ABBREVIATED PLAT AGENDA

STAFF REVIEW AND RECOMMENDATIONS PUBLIC HEARING OCTOBER 22, 2025

ABBREVIATED PLAT: TALKEETNA TOWNSITE L4A L5A B12

ABBREVIATED PLAT: SUTTON ESTATES 2025

Proposed Platting action for Talkeetna Townsite RSB L4A-1 Block 12 #2025-133

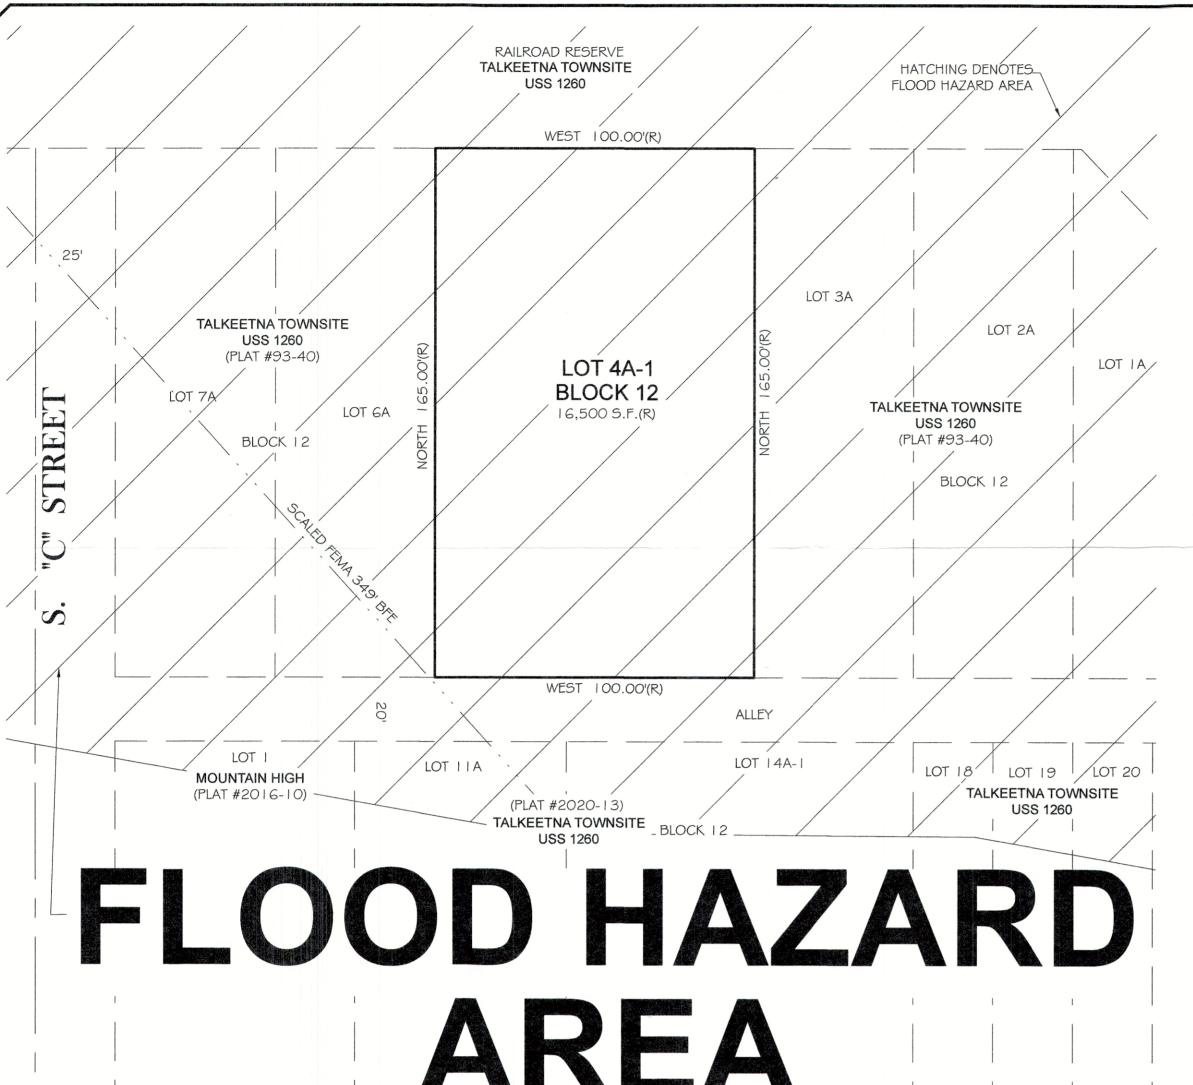
Creating one lot from Lots 4A & 5A Talkeetna Townsite will rectify a setback violation of one structure being over the existing lot line.

The properties are within the West Talkeetna Townsite (WTT) SpUD; where minimum setback requirements are front 10ft, side 10ft and rear 10ft.

There is no issue or conflict with the West Talkeetna Townsite SpUD by creating one lot from the existing two lots.

No as-built or survey document provided that shows the existing structures in relation to the proposed plat to know if there are any other existing or possible setback violations due to the lot line elimination.

No objection to the re-plating action at this time.

SUTTON ESTATES 2025

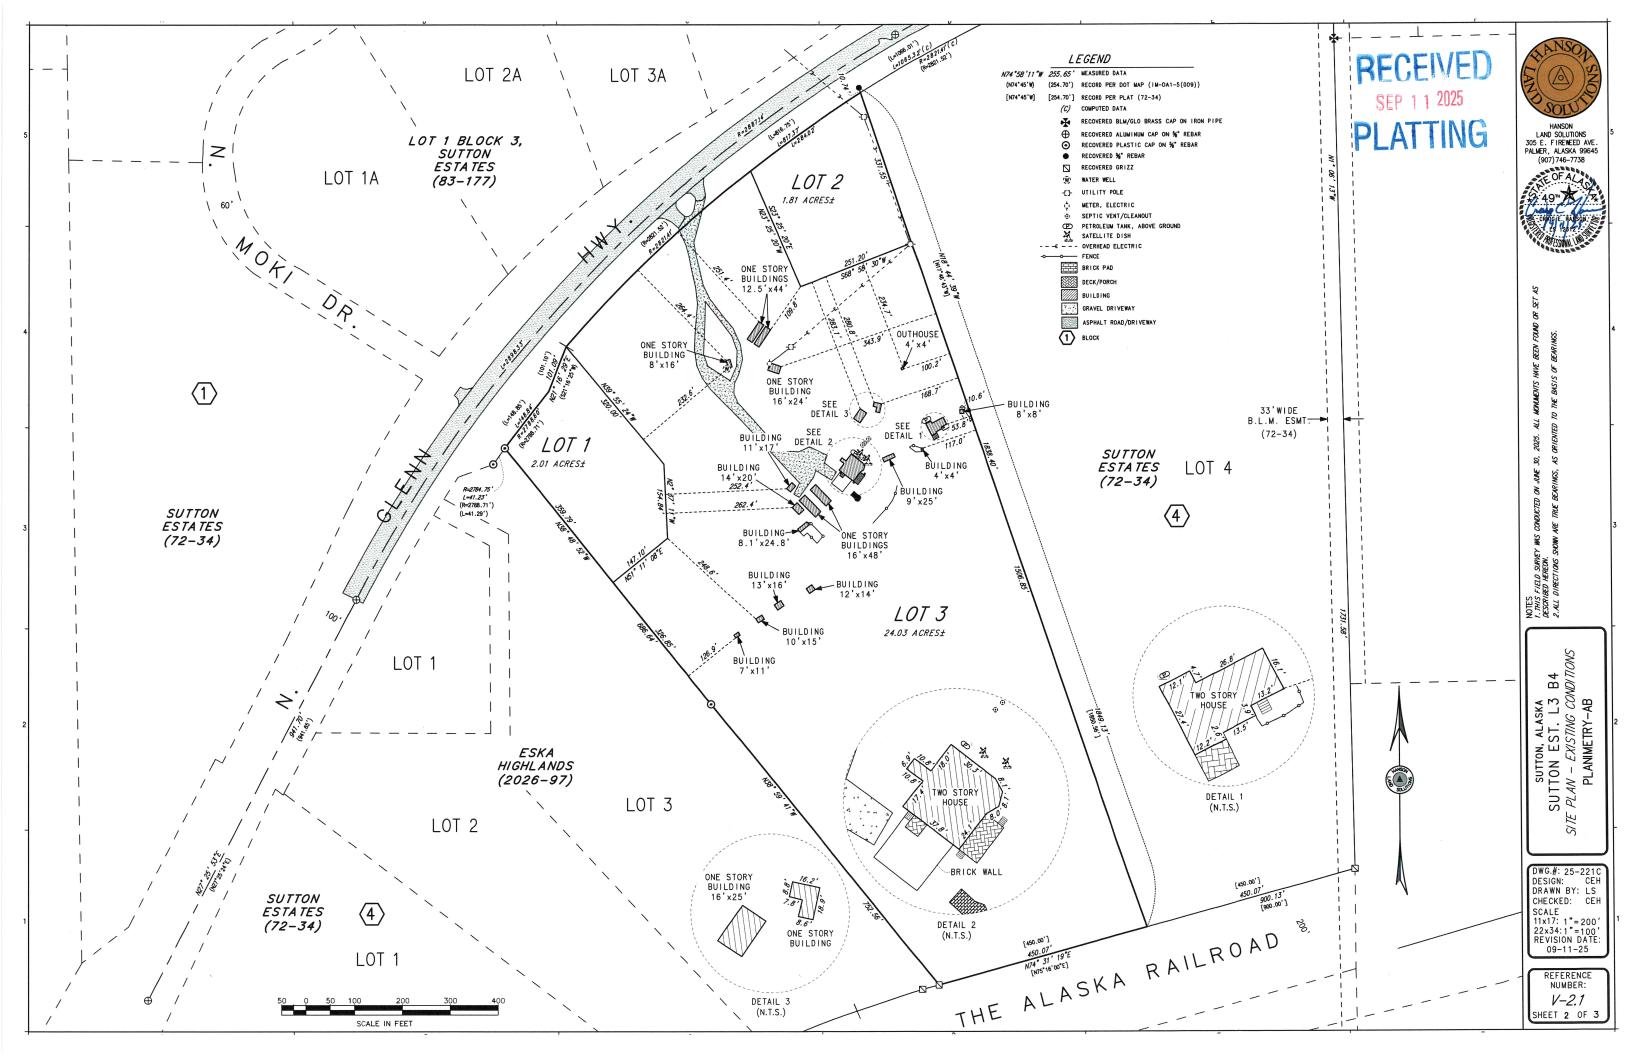
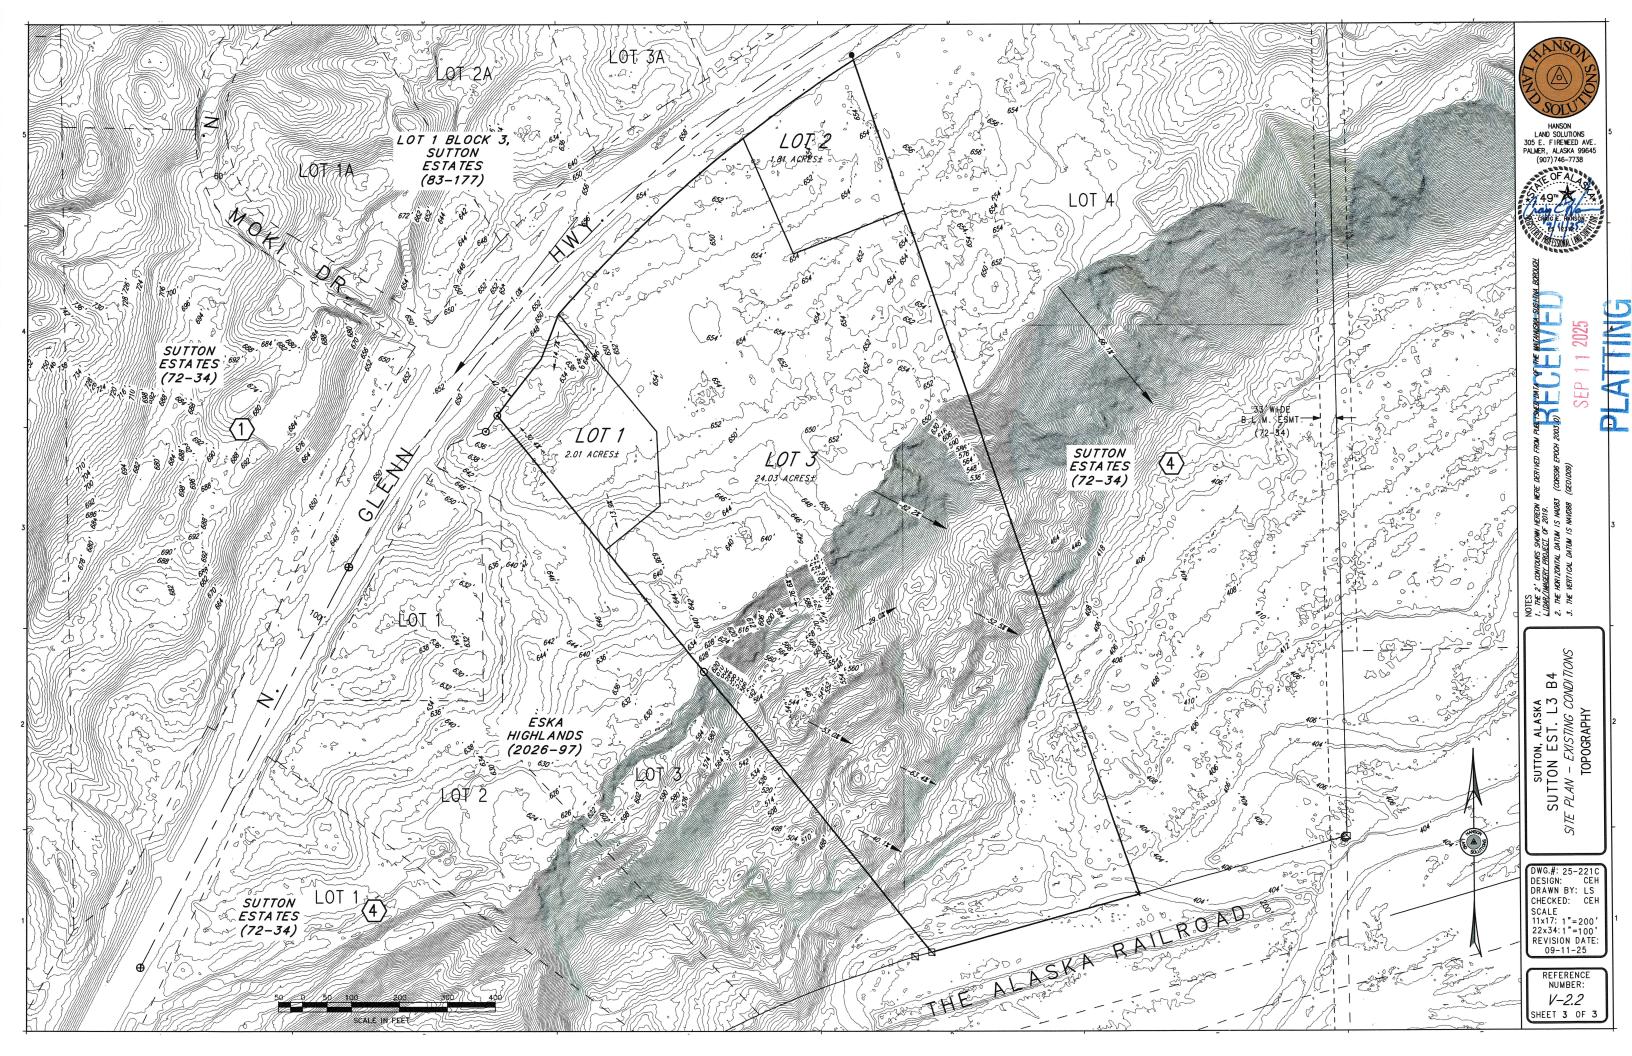
- AKRR has no objection to the proposed subdivision.
- The lands depicted as Alaska Railroad Corporation on the agenda are Lot 1 of USS Survey 9077. Lot was conveyed by the United States to the Alaska Railroad Corporation with Patent 50-2010-0290 recorded in the Palmer Recording District as document #2010-011872-0. Please consider adding the label Lot 1 USS 9077 and the patent number.

- If the 2.5" Aluminum Post monument in Detail 1 is the monument for the Corner 2 Lot 1 of USS 9077 then consider my request for the surveyor to create a note regarding what monuments were held and why on the determination of the ARRC boundary. Consider recovering C1, L1 USS 9077 to defensibly locate the ARRC boundary.

- Consider removing the 200' denotation to the left of Alaska Railroad on the plat. While the ROW is nominally 200 feet, in this area it is defined by the Lot 1 of USS 9077 not exactly 200'. Platting staff notes that AKRR's concerns will be addressed as part of the final review process.

- The lands depicted as Alaska Railroad Corporation on the agenda are Lot 1 of USS Survey 9077. Lot was
 conveyed by the United States to the Alaska Railroad Corporation with Patent 50-2010-0290 recorded in the
 Palmer Recording District as Document Number 2010-011872-0. Please consider adding the label Lot 1 USS 9077
 and the patent number.
- If the 2.5" Aluminum Post monument in Detail 1 is the monument for the Corner 2 Lot 1 of USS 9077 then
 consider my request for the surveyor to create a note regarding what monuments were held and why on the
 determination of the ARRC boundary. Consider recovering C1, L1 USS 9077 to defensibly locate the ARRC
 boundary.
- Consider removing the 200' denotation to the left of Alaska Railroad on the plat. While the ROW is nominally 200 feet, in this area it is defined by the Lot 1 of USS 9077 not exactly 200'.
